E8257D-03

S E R V I C E N O T E

E8257D PSG Analog Signal Generator

Incorrect voltage rating on the Analog Mod Gen capacitor C480

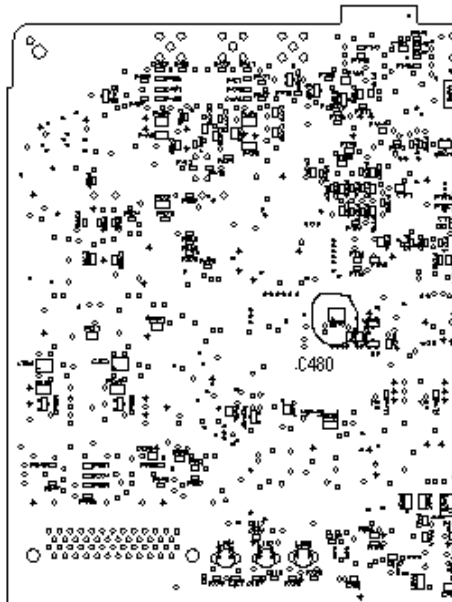
On Analog Mod Gen boards (E8251-60306) with VUF A0100, C480 a filter capacitor on a 15V line was loaded with a 10 V rated part. The capacitor needs to be removed and does not need to be replaced. Removing the capacitor will not cause any performance problems.

C480 is not labeled but can be located in reference to VR451. On the bottom side of the Analog Mod Gen board locate VR451. If the board has not been reworked, slightly to the left of VR451 will be a larger black body surface mount capacitor with a white stripe. The device will be labeled with “10-10 MD” plus the company logo. If C480 is missing or C480 is a yellowish orange color, it was reworked and the VUF was not changed. Using an ESD safe station, remove C480 and re-install the Analog Mod Gen.

When in for repair and/or calibration, check the E8251-60306 VUF number. If the VUF number is A0100, the Mod Gen board needs to be removed and inspected. If the VUF number is A0101, C480 has been changed to the correct voltage rated capacitor and no further action is required. To check the Analog Mod Gen VUF number press “Utility”, “Instrument Info/Help Mode”, and “Installed Board Info”.
